SKILLING, HELLE, CHRISTIANSEN, ROBERTSON — Structural & Civil Engineers

PROJECT: THE WORLD TRADE CENTER | TITLE: TEL/CO REVISIONS TOWER B FL. 11 & 12 | DATE: 12-13-71

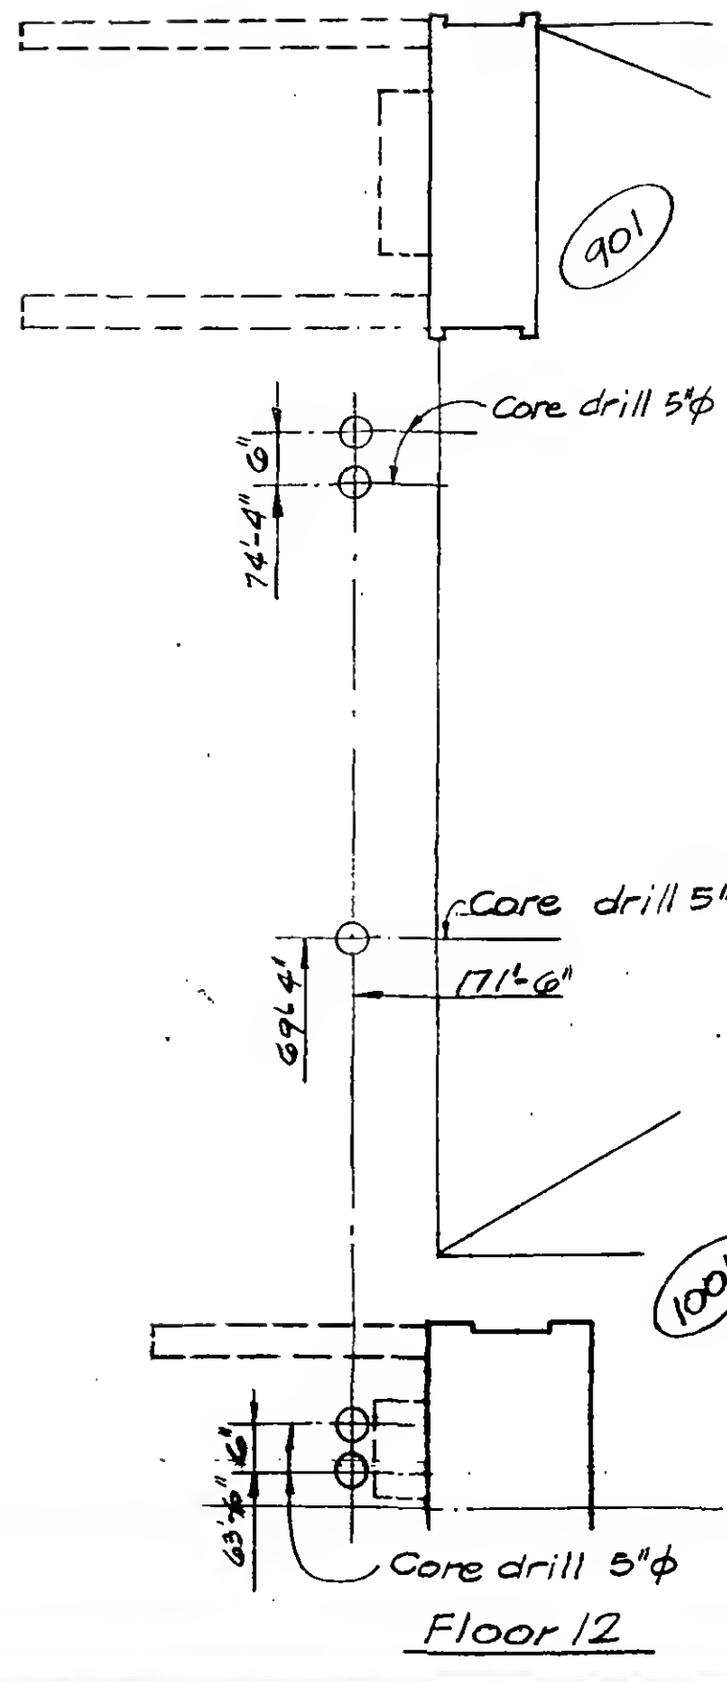
Floor 11

Floor 12

1. Remove existing concrete to line indicated without damaging existing reinf.
2. Adjust existing reinf. without cutting to clear new sleeves or conduits.
3. Add new reinf. as indicated.
4. Clean face of exist. concrete and thoroughly coat entire surface with epoxy bonding compound.
5. Cast slab around new sleeves or conduits using approved "non-shrink" f'c = 4000 psi concrete.
6. Slabs to be shored as required before removing existing concrete.
